International Aero Engines

SERVICE BULLETIN

<u>ENGINE - H.P. COMPRESSOR VARIABLE STATOR VANES - INTRODUCTION OF STAGE 6 VANES MADE OF</u>
IMPROVED CORROSION RESISTANT MATERIAL - CATEGORY CODE 6 - MOD.ENG-72-0169

V2500-ENG-72-0169

Location of stage 6 variable inlet guide vanes Fig.1

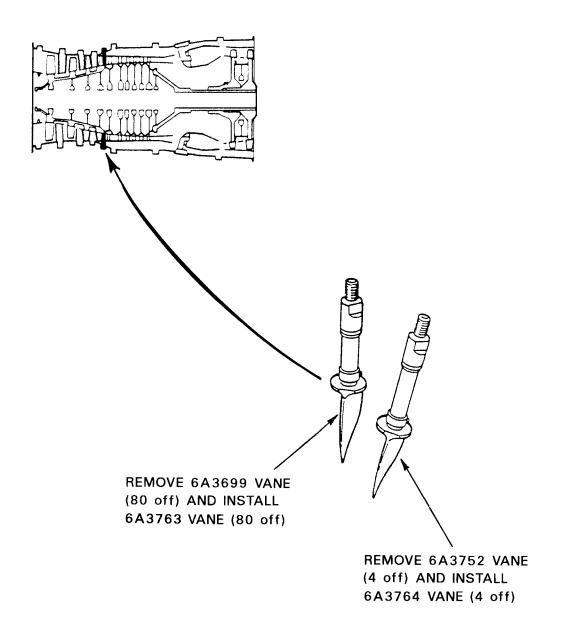
Stage 6 variable stator vanes in improved corrosion resistant material. Changing the material incurs a weight penalty and to partially compensate for this the vane spindle waist diameter is reduced to 0.298 in. (7,57mm) from 0.324 in. (8,22mm).

The material properties are such that this can be achieved without compromising spindle strength.

- B. Assembly Instructions
 - (1) New 6A3763 and 6A3764 stage 6 H.P. compressor variable stator vanes are only interchangeable as a COMPLETE SET with in-use vanes.
 - (2) Assemble 6A3763 and 6A3764 stage 6 H.P. compressor variable stator vanes by use of approved procedures in the Engines Manual, 72-41-30 Assembly.
- D. Recording Instructions
